PLANNING BOARD AGENDA
OCTOBER 22, 2014 – 7:00 P.M.

Re: Cargain Funeral Home - Amended Site Plan
418 US Route 6
Town of Carmel, Putnam County
Tax Map #: 75.15-1-6

This letter is in response to the memorandum dated September 16, 2014 from Mr. Richard J. Franzetti, PE, Town Engineer regarding his comments from our September 4, 2014 submittal for the Amended Site Plan for the above referenced project. Please note that our responses to the comments are in **bold** print.

PROPOSED ELEVATIONS - OPTION A

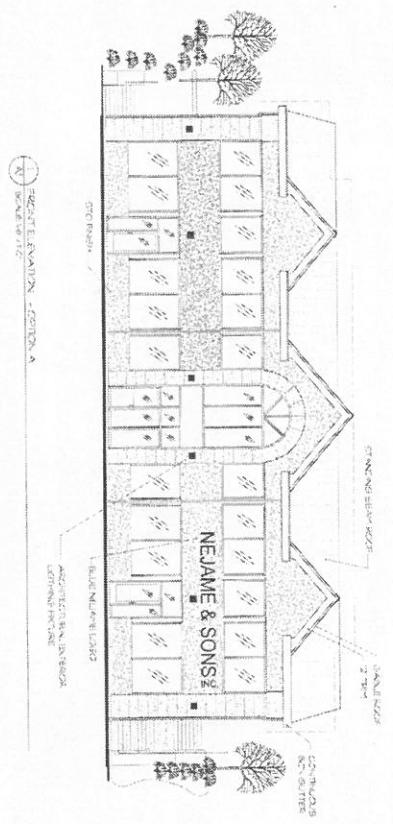
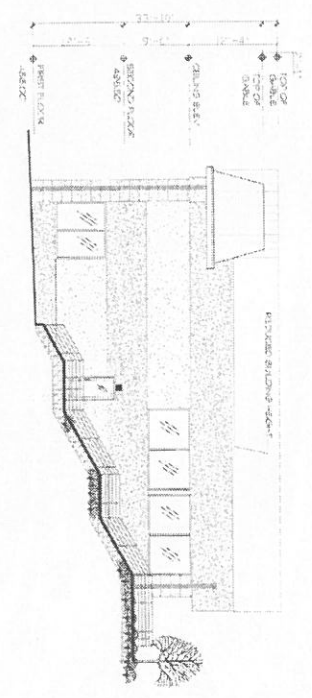
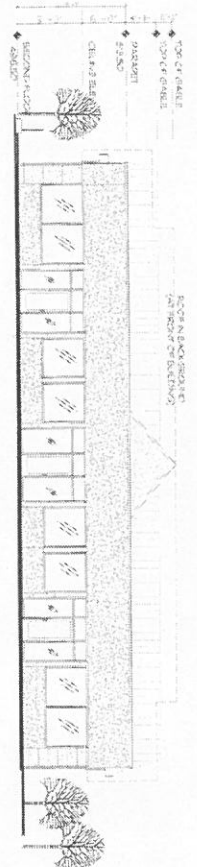
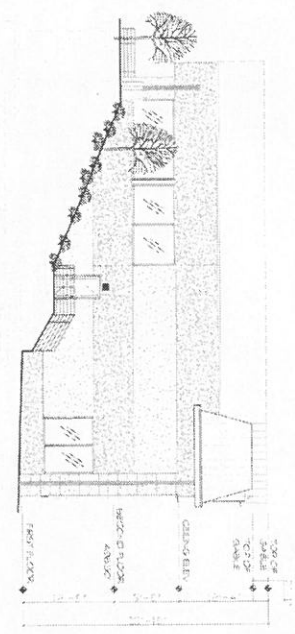
- (i) pitched standing seam roofing;
- (ii) addition of three (3) gabled roof elements along building front;
- (iii) 12 inch trim along gables and roofline;
- (iv) addition of end columns using horizontal "block" detailing;
- (v) revised archway using horizontal "block" detailing;
- (vi) addition of exterior architectural lighting;
- (vii) Sto exterior finish and insulation using earth tones to blend with landscaping elements;
- (viii) box gutter on front façade emulating residential aesthetic;
- (ix) revision to larger, continuous windows for retail exposure and open office planning;
- (x) repositioned, smaller corporate logo on building façade;
- (xi) reduction in building height due to elimination of mezzanine above second floor; and

- (xii) use of architectural block in exterior stairways consistent with building finish and retaining walls.

TITLE:
TURNING RADII DIAGRAM

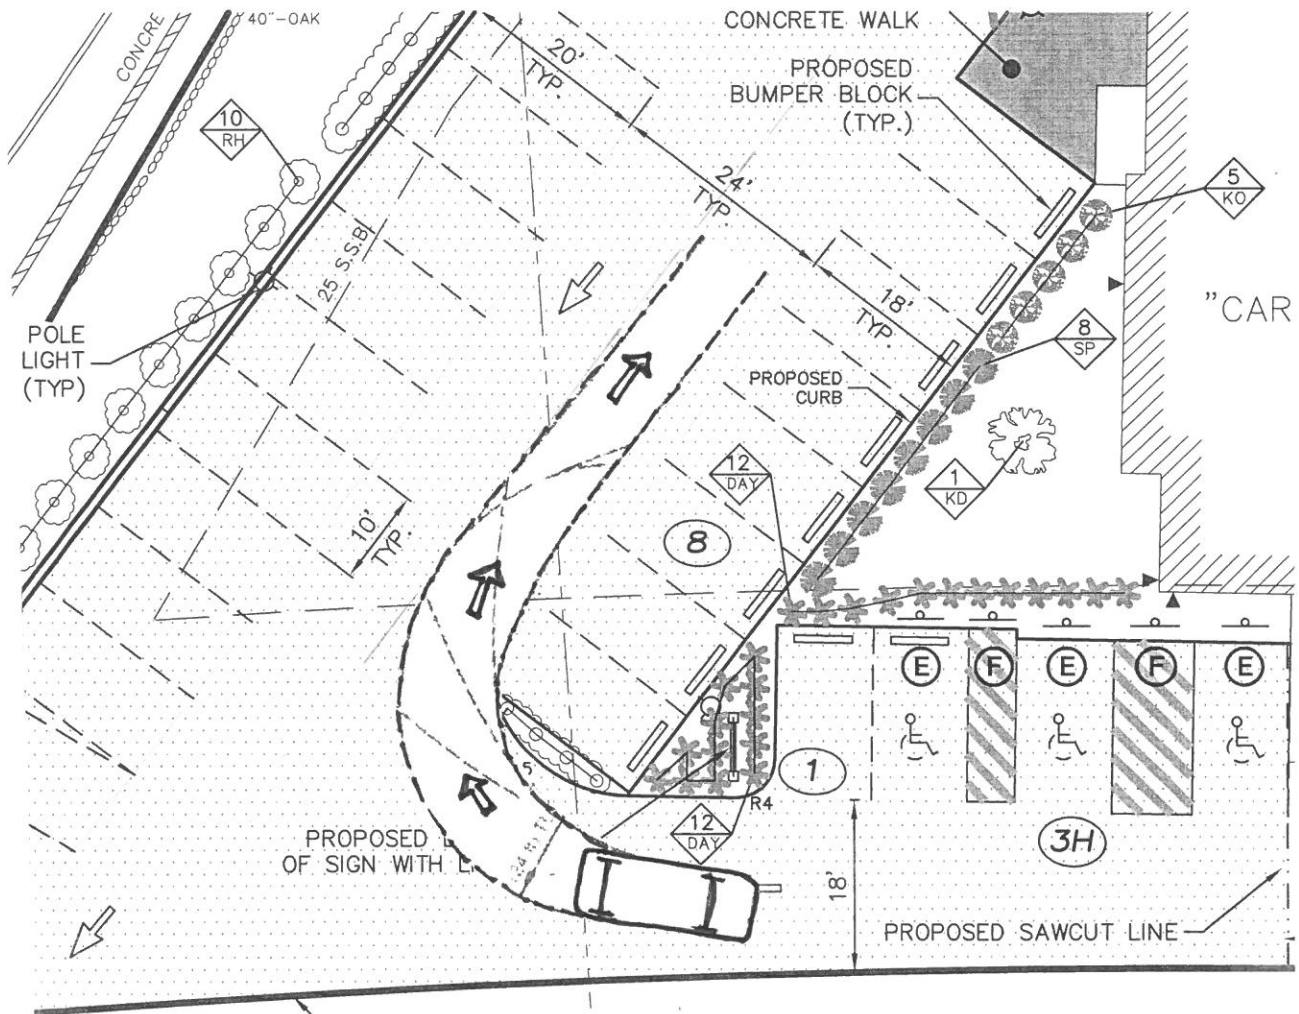
13. Graphic representation of vehicle movements through the site should be provided to illustrate that sufficient space exists to maneuver vehicles.
Response: A sketch entitled "Turning Radii Diagram at Parking Isle Turn" Sheet 1 of 2 is enclosed showing there is sufficient space for the movement of vehicles through the site.

TITLE:
TURNING RADII DIAGRAM

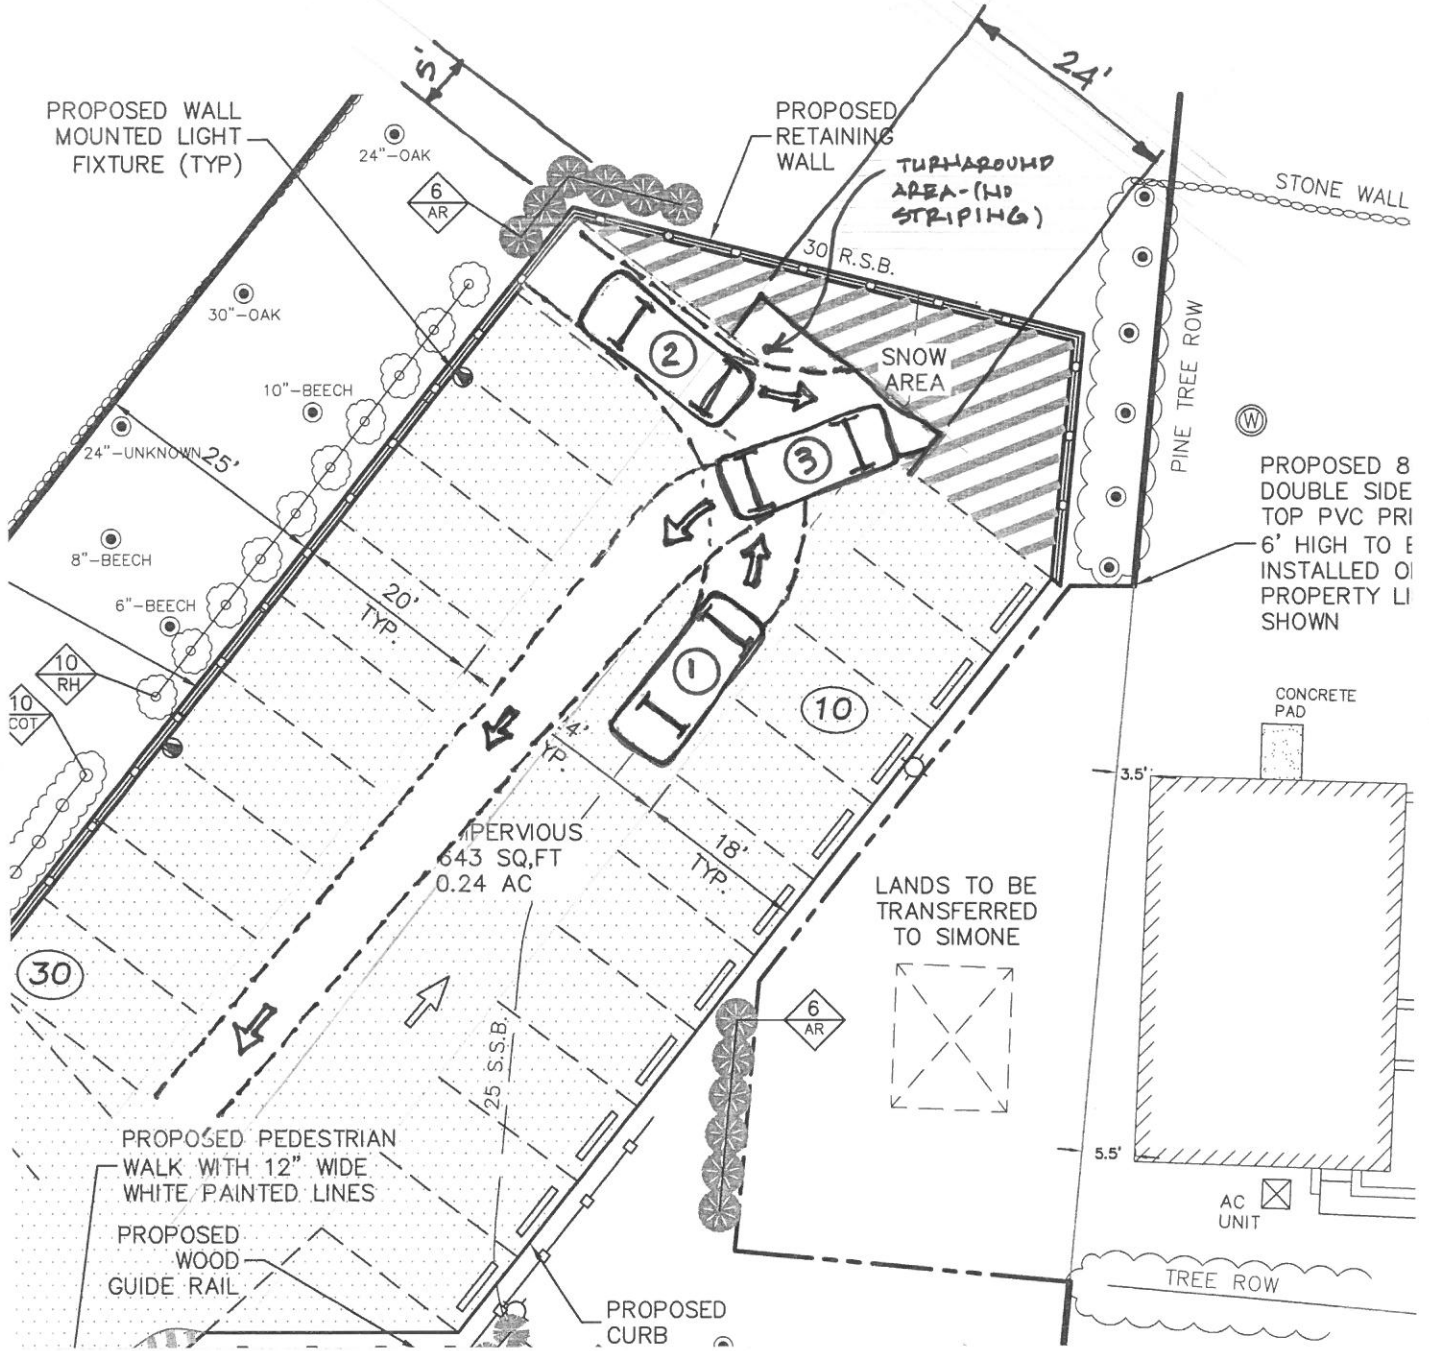
14. All turning radii for the site should be graphically provided. This includes the turning radii into the modified site entrances.
Response: A sketch entitled "Turning Radii Diagram at Parking Space" Sheet 2 of 2 is enclosed showing the turning radii at the site entrances.
